Town of Philipstown

2/17/21
Gary and Sue Onishenko
28 Lake Celeste
Garrison NY 10524
Tax map # 72.17-1-12
RC zone

Ref: Application for building permit for an addition and legalization of existing deck

3 A001 SITE PLAN WITH ADDITION
(REFER TO SURVEY PREPARED BY PAUL ROWAN, DATED OCTOBER 5, 2020 FOR ADDITIONAL INFORMATION)
SCALE: 1/16" = 1'-0"

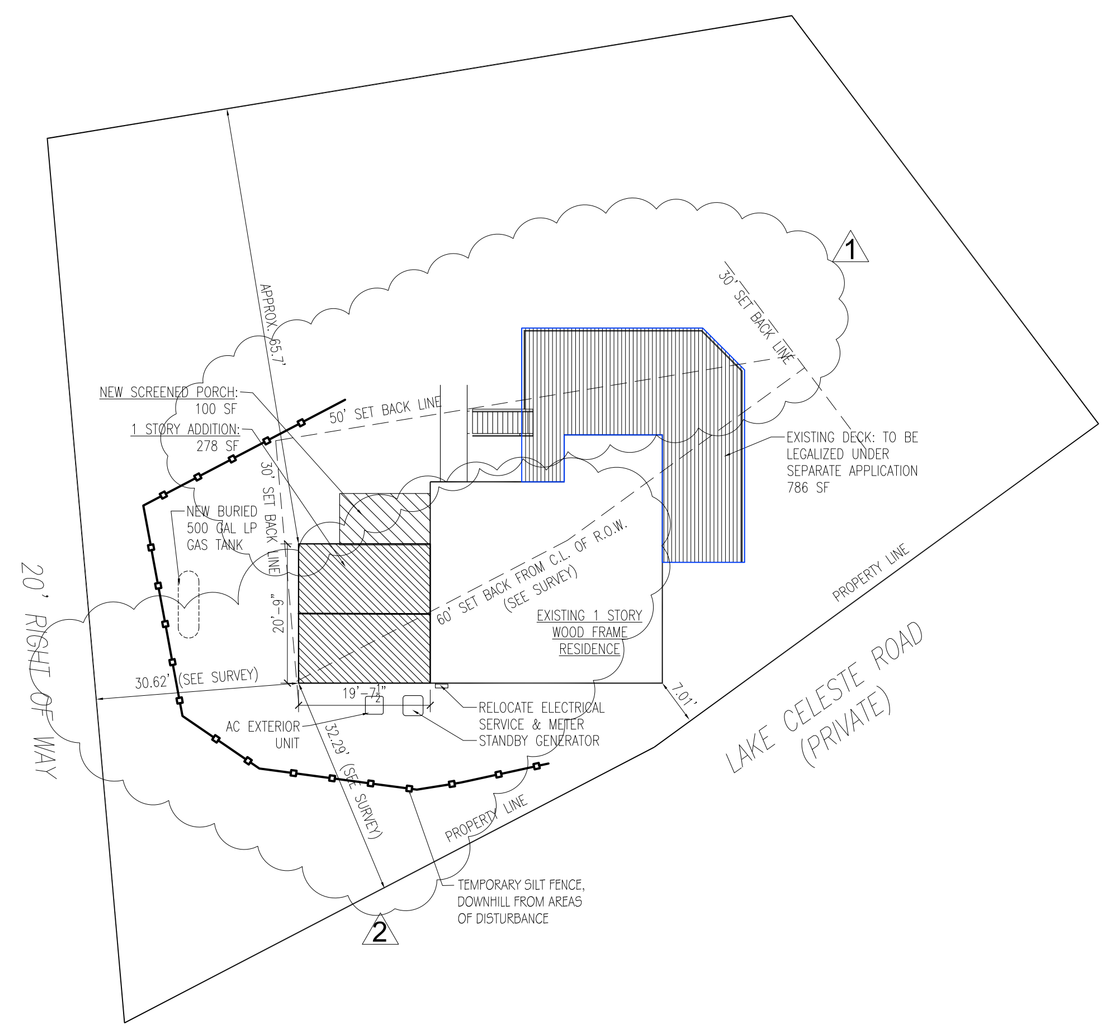
The application proposes the legalization of an existing deck where the required front yard setback is 60' feet and the existing setback is 40.25' feet.

The proposed addition to the existing house appears to comply with the front and side yard setbacks.

The existing house is pre-existing non-conforming with a front yard setback of 32.14' feet where 60' feet is required.

Since the proposal does not comply with the requirements of the Town of Philipstown town code Chapter 175 Zoning code the application is denied.
